भारत सरकार
Government of India
विद्युत मंत्रालय
Ministry of Power
उत्तर क्षेत्रीय विद्युत समिति
Northern Regional Power Committee

Subject: Minutes for 59th Protection Sub-Committee Meeting.

59th Protection Sub-Committee Meeting (23rd April, 2025)-MoM

Minutes of
59th Meeting of Protection Sub-Committee (PSC) of
Northern Regional Power Committee

Sequence of Events

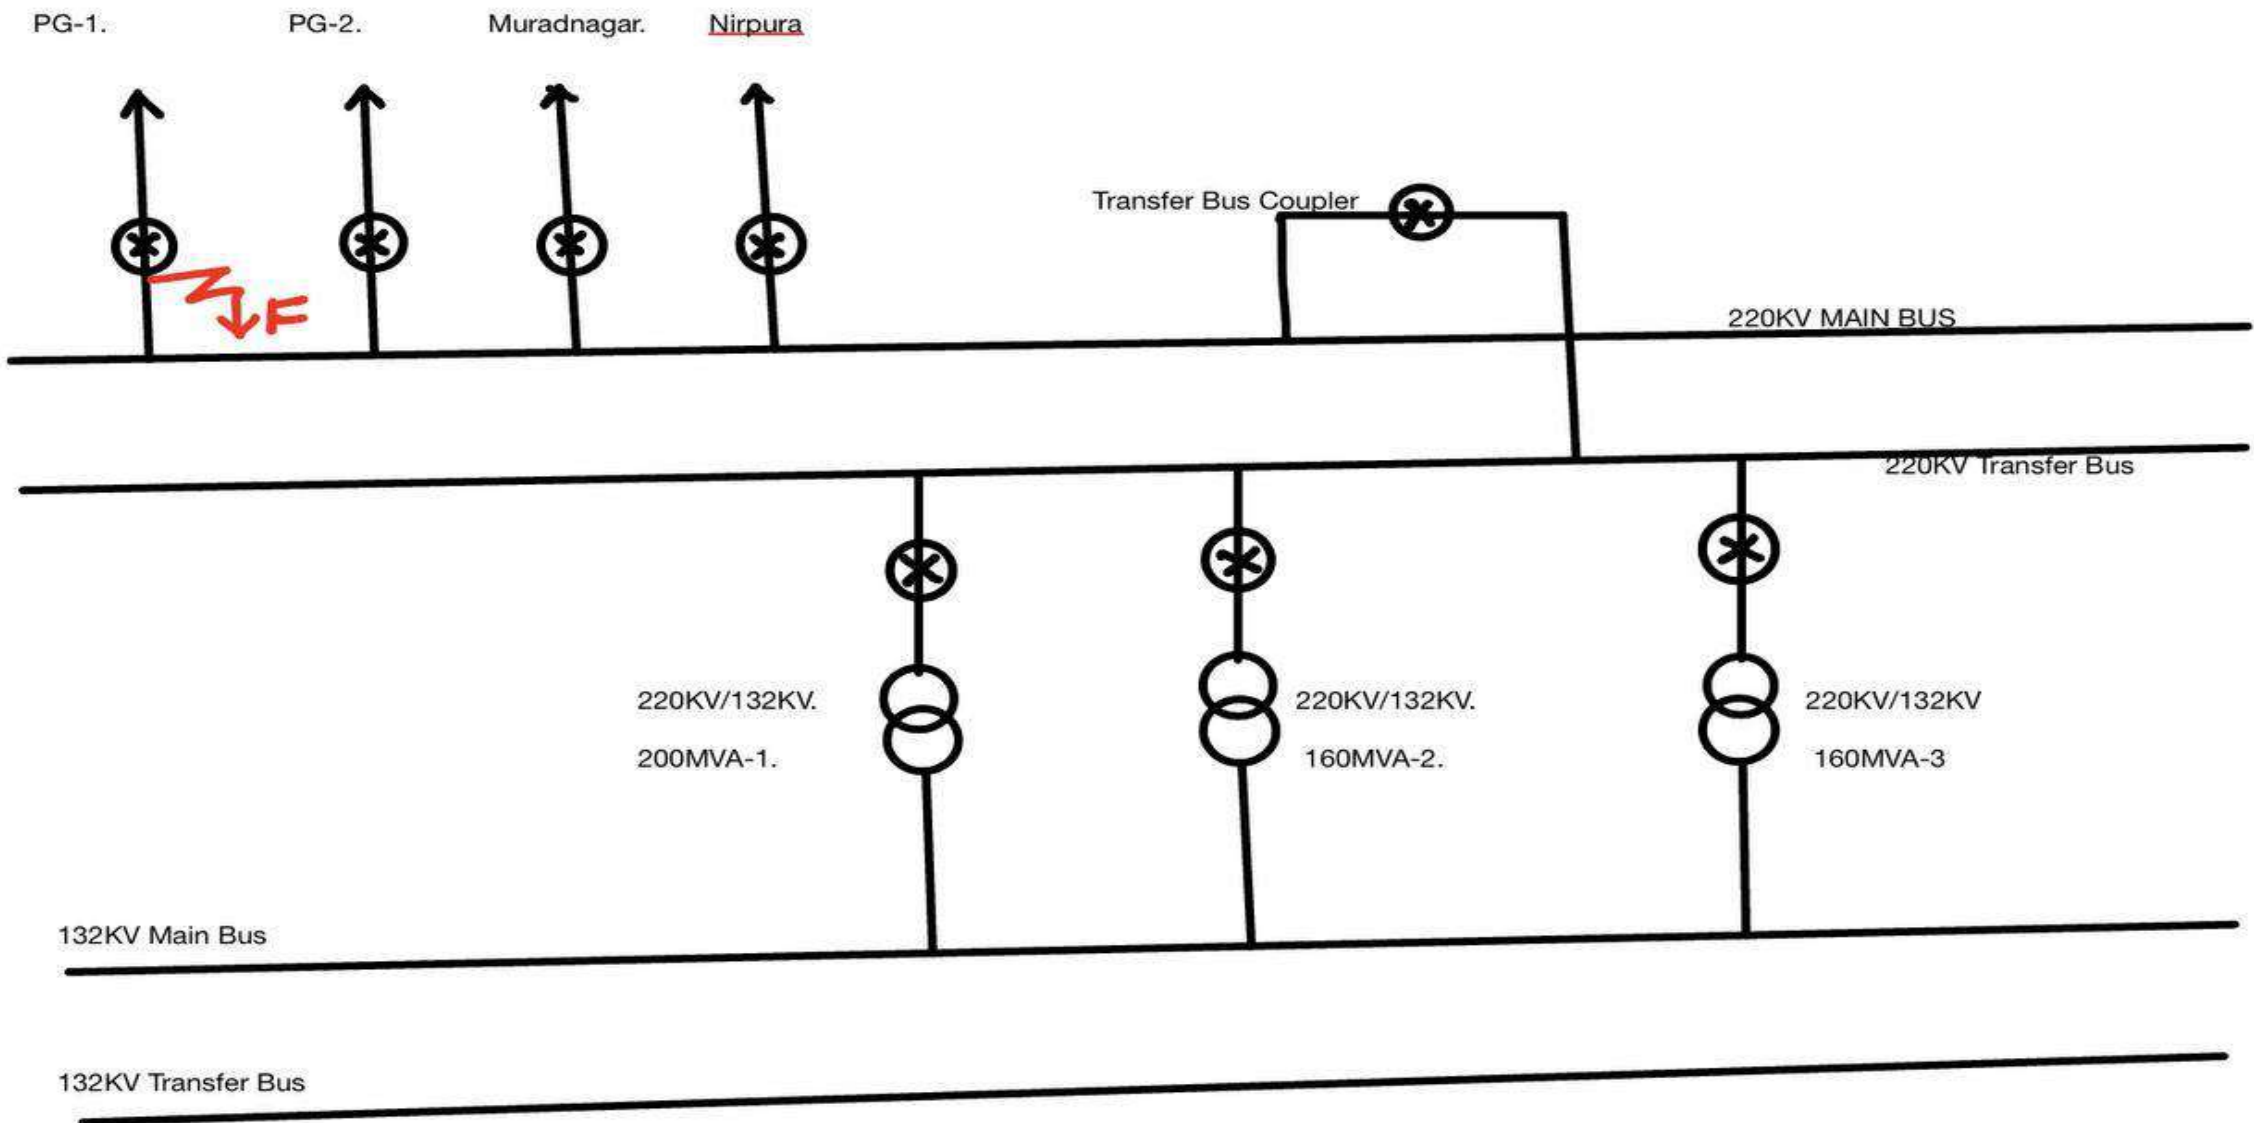
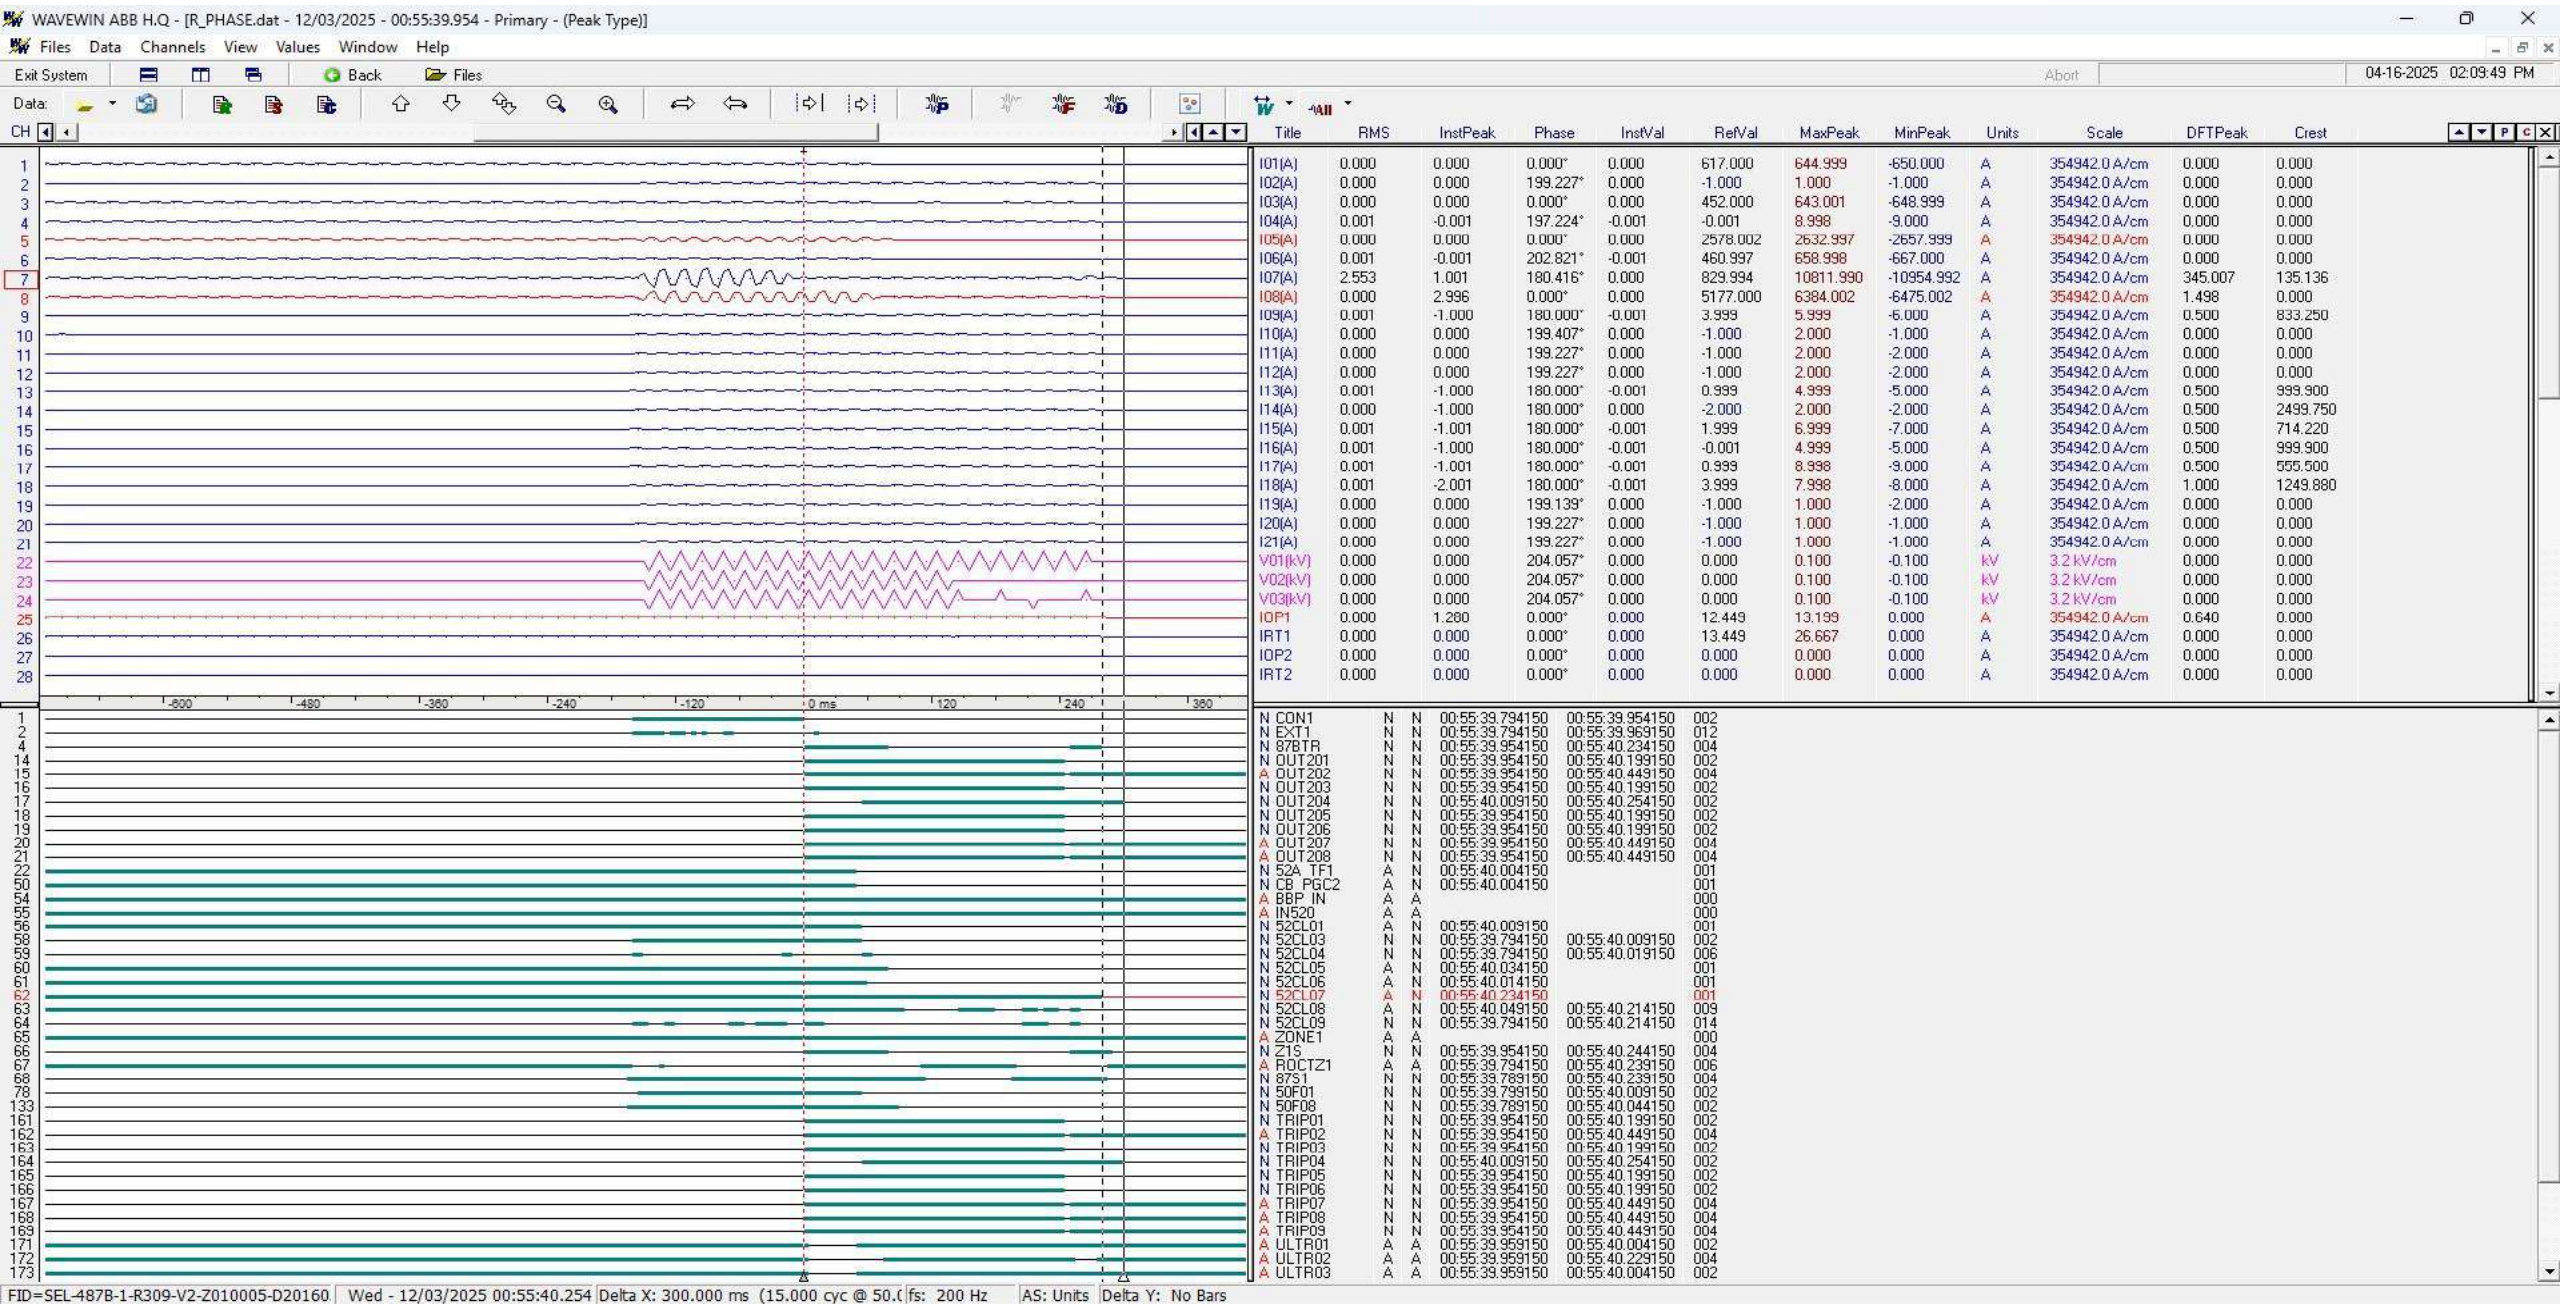
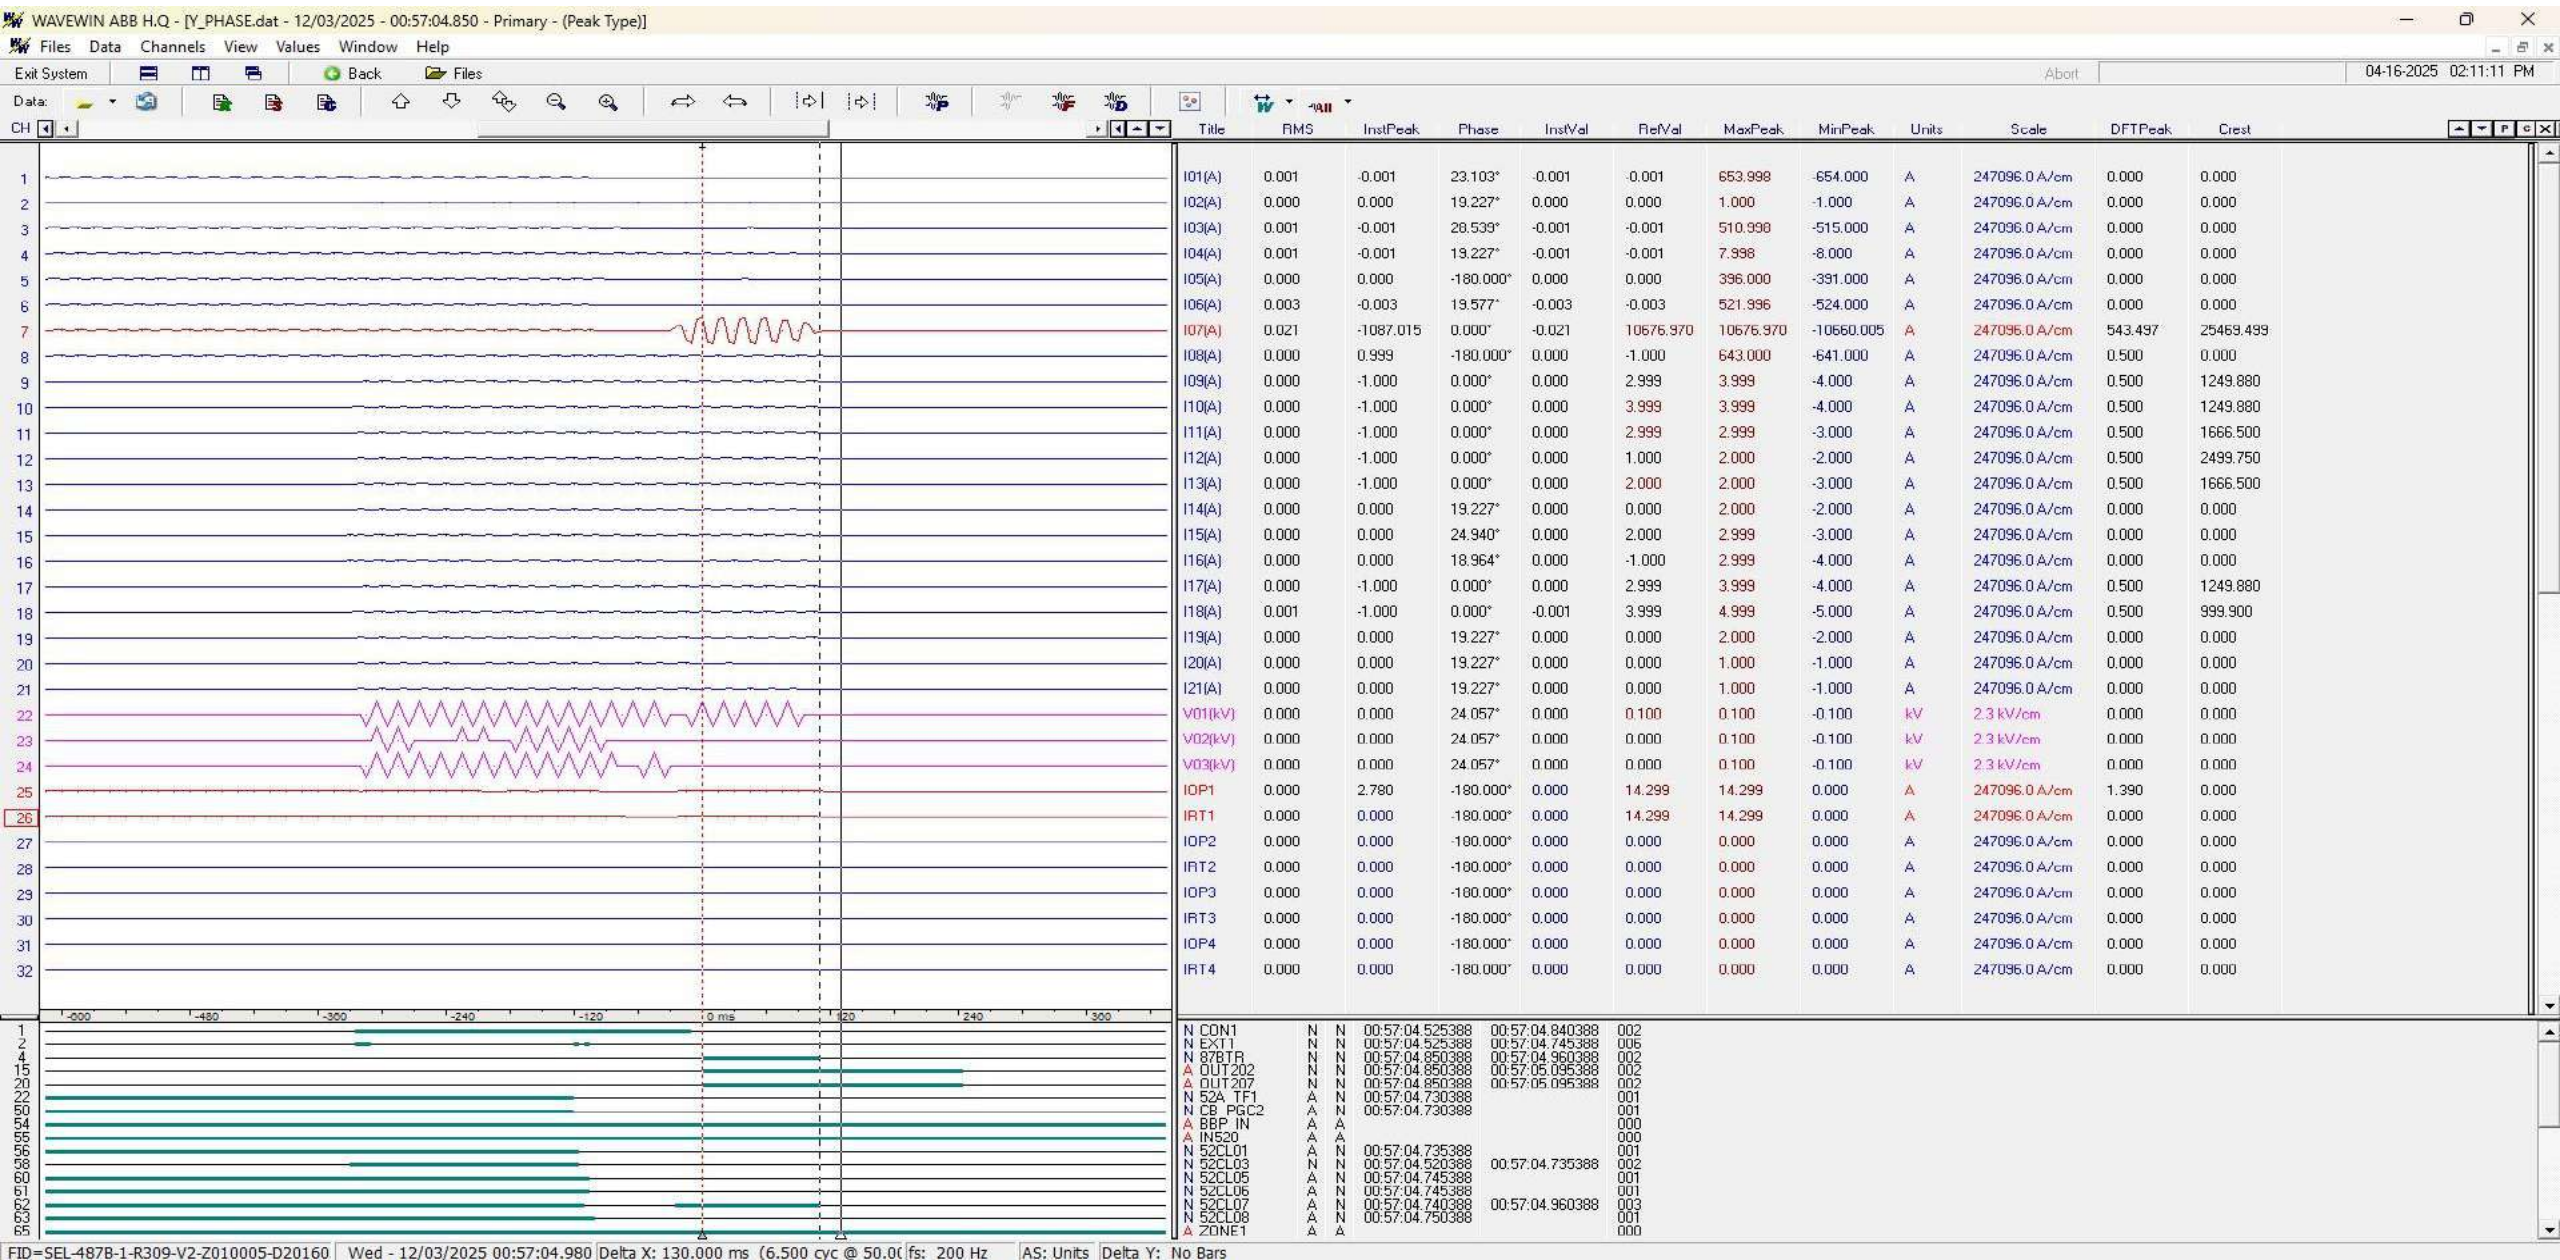
1. R-phase CT of 220KV Baraut-Baghpat (PG)-I line got damage and R-phase Jumper came in range with the Y-phase CT clamp head, thereby fault converted from Single-phase to Phase fault.
2. This CT damage resulted operating current $I_{op} = 10.16A$ and restraining current $I_{rest} = 18.402A$ in the Bus-Bar relay causing Bus-Bar operation.

Following elements got tripped due to Bus-Bar operation.

- a. Bay1 – 160MVA T/F-II
- b. Bay2 – Bus Coupler
- c. Bay3 – 200MVA T/F-I
- d. Bay4 – 220KV Baraut-Nirpura Line
- e. Bay5 – 220KV Baraut-Muradnagar Line
- f. Bay6 – 160MVA T/F-III
- g. Bay7 - 220KV Baraut-Baghpat (PG)-I Line
- h. Bay8 - 220KV Baraut-Baghpat (PG)-II Line

- Thorough checking of healthiness of CT is essential for preventing such incidents. UPPTCL has initiated a program for checking the healthiness of old and vulnerable CTs which includes TAN DELTA and partial discharge test on CTs.
 - DT scheme on this line should be jointly checked by UPPTCL and Baghpat PGCIL after availing shutdown of the line.
-
